## PLAN COMMISSION

September 10, 2019

**Proposal:** Plan Review – Screening Modifications for Edgewood Elementary School

**Proposal:** Plan Review – Site, Landscaping, and Screening Modifications for Meadowview Elementary School

DRAWING NUMBER  
**M401**  
EES  
Nexus Solutions, LLC

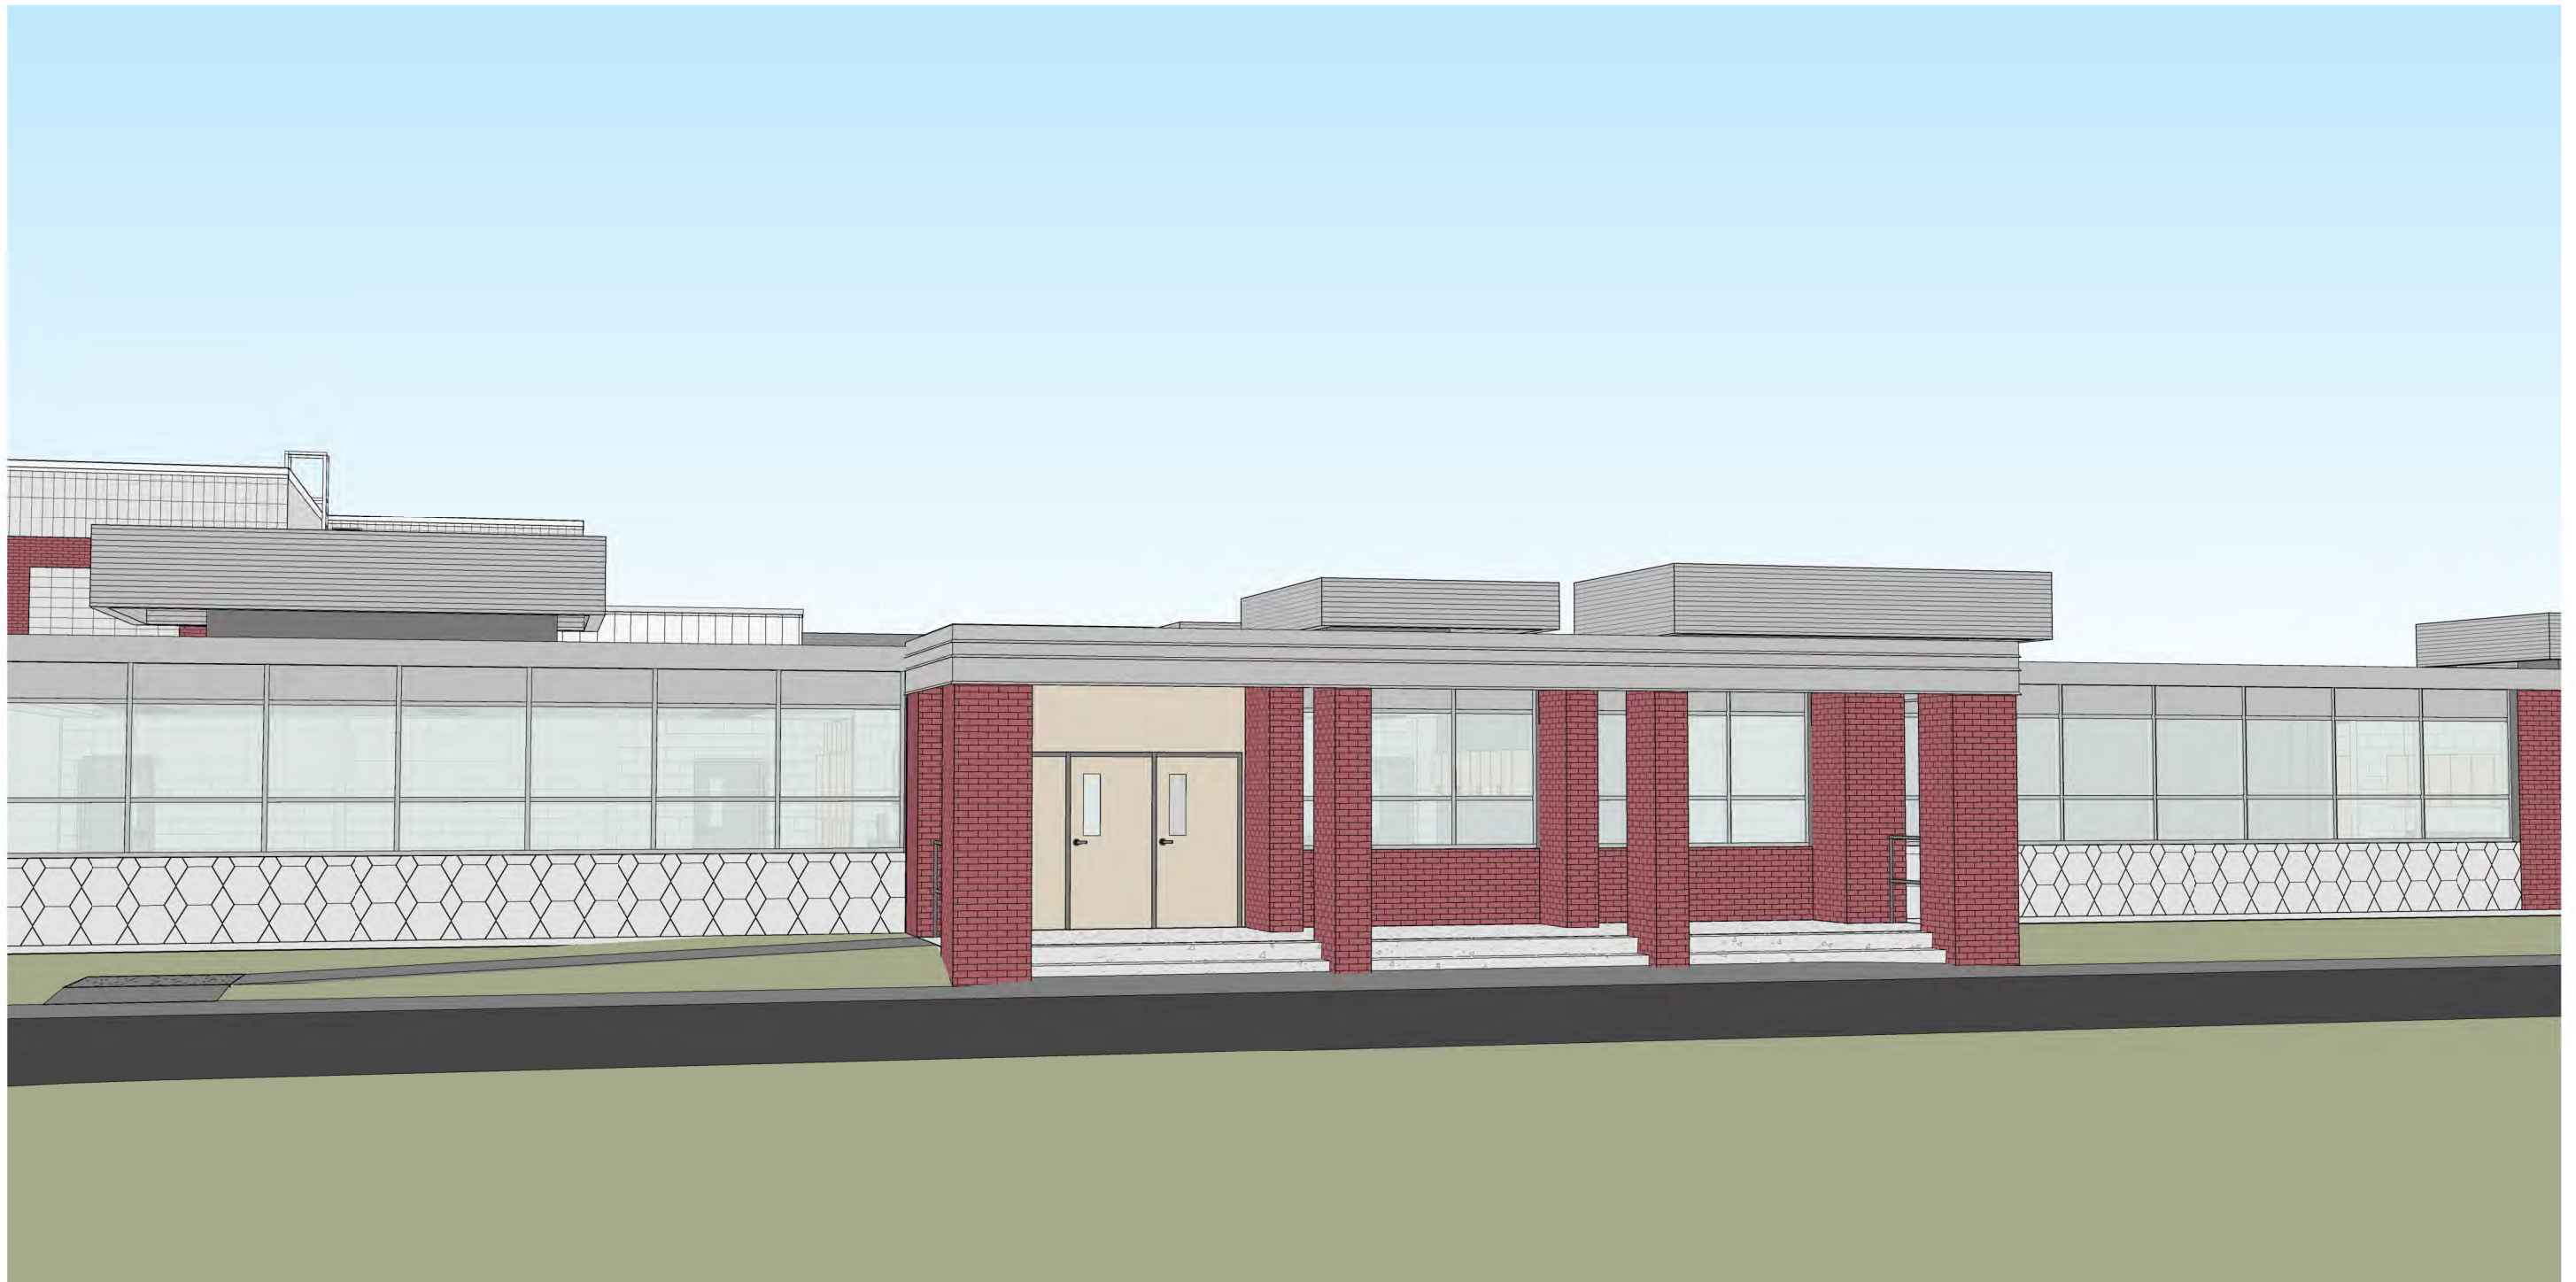
At the March 12, 2019 meeting, the Plan Commission approved site plans for modifications to the parking lot, a new access drive and parking lot, an elevator addition, and an addition for a new gymnasium for Meadowview Elementary School at 10420 S. McGraw Dr. Plan Commissioners may recall that existing rooftop mechanical units (RTUs), which are not currently screened, were to be replaced with larger RTUs. Per Section 17.1010(g) of the Municipal Code, “roof mounted mechanical equipment shall be screened from casual view.” Additionally, landscape islands within the parking lots per Sections 17.0403(g) and 17.1010(b) were required. The Applicant is requesting a modification to remove these requirements from the plans.

As mentioned in the previous staff report for Edgewood Elementary School, while staff can appreciate that the existing RTUs have not historically been screened, any change to the existing conditions requires conformance with Code. This is true for any site or building modification within the City. Staff disagrees with the assessment in the submitted narrative that screening will make the RTUs more visible from the road, and that screening will be less aesthetically pleasing than exposed RTUs. Rather, screening as included in the submitted examples and throughout the City generally have the effect of blending with the architecture of the building. Those structures that do not incorporate RTU screening are more visible from the road, and are the examples of why the Code requires screening. Staff have consistently included in Conditions of Approval for Plan Commission consideration that all mechanical equipment, transformers, and utility boxes (ground, building, and rooftop) are screened from view per Code requirements, including in this case.

- Existing RTU being replaced was: 58" w x 88" l x 50" h on top of ~12" curb.
- New RERVU is: 95" w x 128" l x 50" h on top of 14" curb. The unit is longer due to energy recovery and wider due to DX cooling module.
- With the RERVU having a housing dimension of 58" w x 128" l x 50" h (not including DX module and outdoor hood), adding screening results in: 154" w x 224" l x 50" h. Therefore the screening with add 59" of obstructed view at this unit.
- Other locations we're combining existing RTU to single RERVU or moving existing roof edge located RTU away from edge
- Adding screening to RTU's on this building will add a total of 8' of obstructed view to the roof of the building.

1. That all relevant Code requirements remain in effect.
2. That all conditions of approval from March 12, 2019 remain in effect except as specifically amended herein.
3. That the proposed rooftop mechanical units are not required to be screened at this time; however, any changes to the rooftop mechanical units will require screening at the time of installation.
4. That the three (3) landscape islands in the south parking lot are not required to be installed at this time; however, any change(s) to the parking area will require landscaping in conformance with Code requirements in effect at the time of the change(s).
5. That all detailed, revised plans are submitted in digital format to the Department of Community Development prior to submission of permit applications.
